# A d d e n d u m

Iowa Department of Transportation  
Office of Contracts

<b>B.O.</b>	<b>Proposal ID</b>	<b>Proposal Work Type</b>	<b>County</b>	<b>Project Number</b>	<b>Addendum</b>
106	66-C066-049	PCC OVERLAY - UNBONDED	MITCHELL	STP-S-C066(049)--5E-66	21JAN106.A02

SHEET B.01:

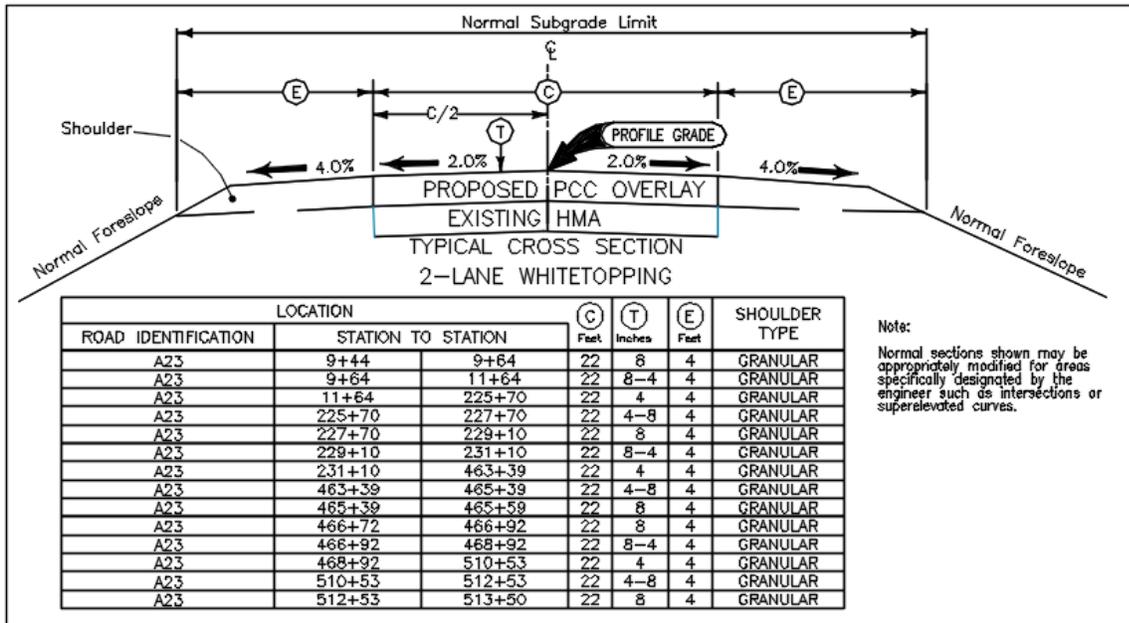
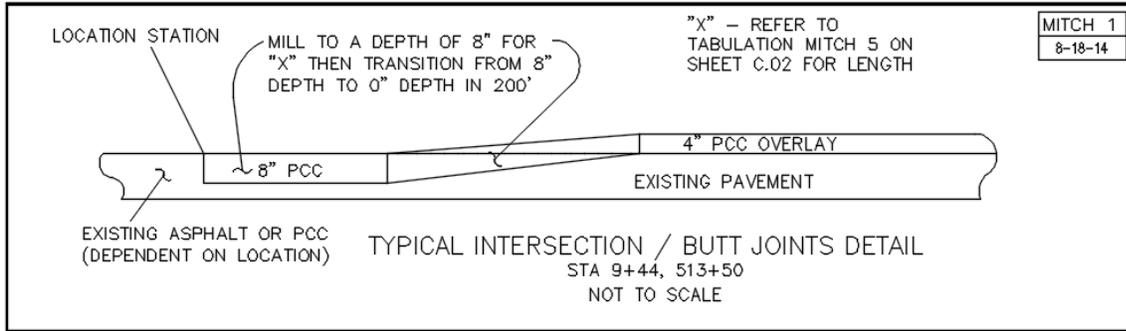
Replace the DETAIL MITCH 1 with the attached DETAIL MITCH 1
